Access Compliance Report

Public Rights-of-Way

(Curb Ramps)

Intersection ID: 26242	Main Street: BAYBROOK_LN	Cross Street: BEVINGTON_PL	Location:	N
ADA ID: 13A831751FBD	Ramp Type: PerpDiag	Initial Pass/Fail: Fail	Overall Compliance: No	Severity Score: 37.5
Codes/Mitigation Info/Possible Solution		Field Measurements/Component Compliance

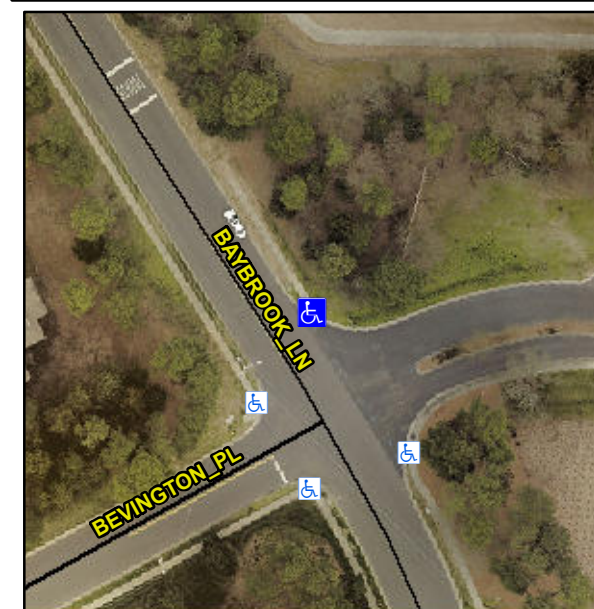
Not Found, R304.2.2, R304.5.3

Compliance	Description	Data	Compliance	Description	Data
N/A	Ramp Length (in)	32.0	No	Ramp Slope (%)	8.4
Yes	Ramp Width (in)	48.0	No	Ramp XSlope (%)	7.6
N/A	Flare Type LT	N/A	N/A	Flare Type RT	N/A
N/A	Flare Slope LT (%)	N/A	N/A	Flare Slope RT (%)	N/A
N/A	Flare Traversable LT?	N/A	N/A	Flare Traversable RT?	N/A
N/A	Landing Length (in)	N/A	N/A	DWS Provided?	N/A
N/A	Landing Width (in)	N/A	N/A	DWS Contrast?	N/A
N/A	Landing Slope (%)	N/A	N/A	DWS Length (in)	N/A
N/A	Landing X Slope (%)	N/A	N/A	DWS Full Width?	N/A
N/A	Landing Curb? (Y/N)	N/A	N/A	DWS Offset (in)	N/A
N/A	Shared Landing?	N/A			
N/A	Gutter Ponding?	N/A	N/A	Gutter Slope (%)	N/A
N/A	Gutter Lip Ht (in)	N/A	N/A	Gutter X Slope (%)	N/A
N/A	Painted X Walk1?	No	N/A	Painted X Walk2?	No
	X Walk 1 Direction	To SW		X Walk 2 Direction	To SE
N/A	X Walk 1 Width (in)	N/A	N/A	X Walk 2 Width (in)	N/A
	X Walk 1 Slope (%)	1.3		X Walk 2 Slope (%)	1.6
	X Walk 1 X Slope (%)	2.8		X Walk 2 X Slope (%)	7.1

Remove & Replace Curb Ramp With Two New Directional Ramps or Equivalent.
